# Wellington City Council Proposed District Plan Hearing Stream 4 – Centres

## Zone Recommendations

To assist the presentation of Evidence of N.Rae  
20/06/2023

# Island Bay (nth) LCA NCZ

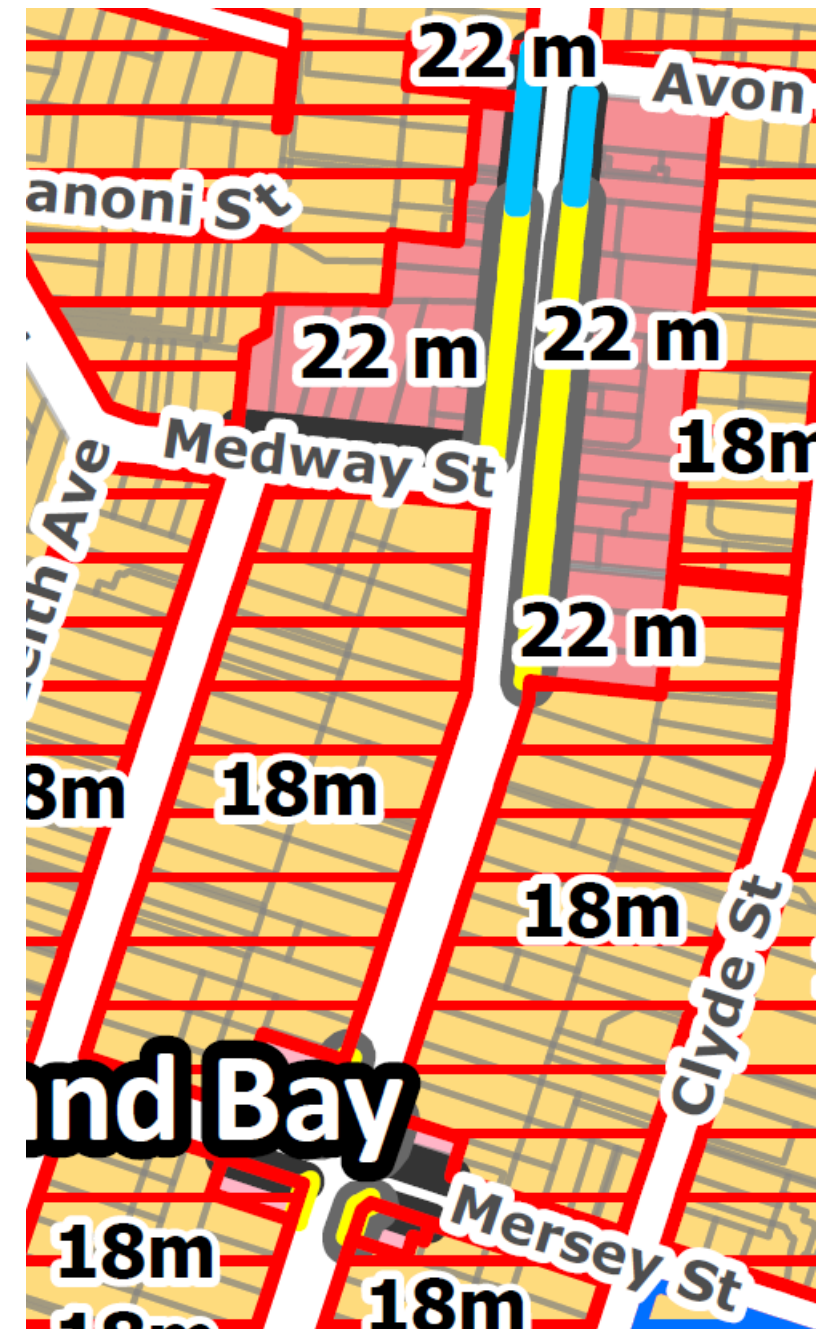
- **Position:** Support LCZ and NCZ
- **Recommended changes:** Extend active frontage and verandah controls as per the blue line.
- **Comment:** Different centre scale, apply consistent frontage requirement to centre to enhance pedestrian amenity and centre form

# Kilbirnie MCZ

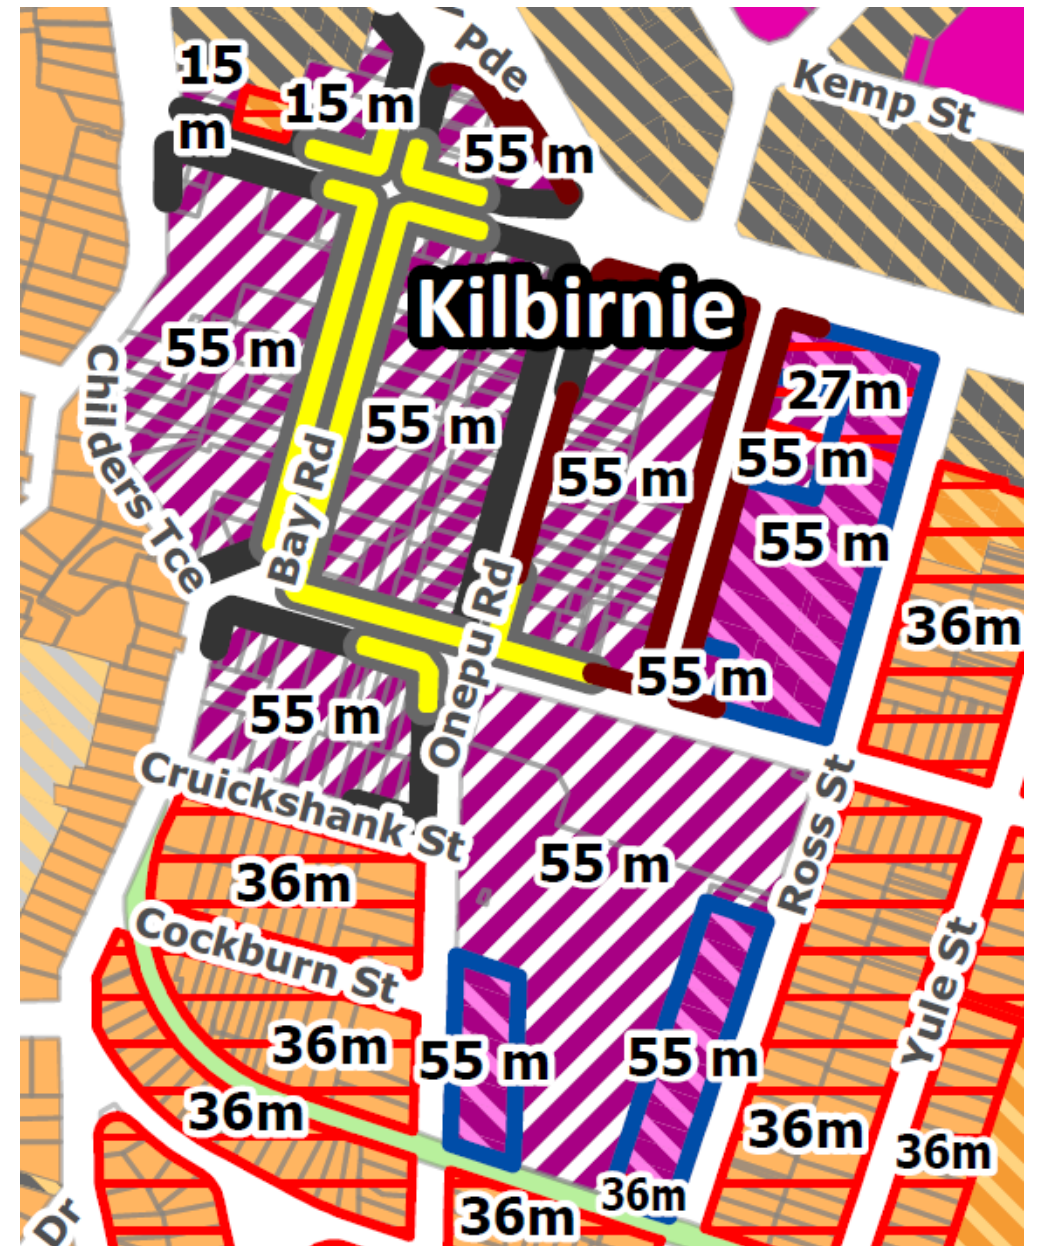
- **Position:** Support MCZ, and Kāinga Ora's submission to expand centre and increase height standard to 55m to most of MCZ
- **Recommended changes:** Expand non-residential at ground floor frontage control as per brown line.
- **Comment:** expand MCZ to Ross Street as this provides a better interface for residential opposite than at Mahora Street due to existing context (supermarket)
- Retain 15m at north west and 27m height overlay to north expansion area as transition to MRZ
- Expand MCZ either side of Bus Barns site to enable whole block to respond and avoid HIRB restrictions on the Bus Barns site.
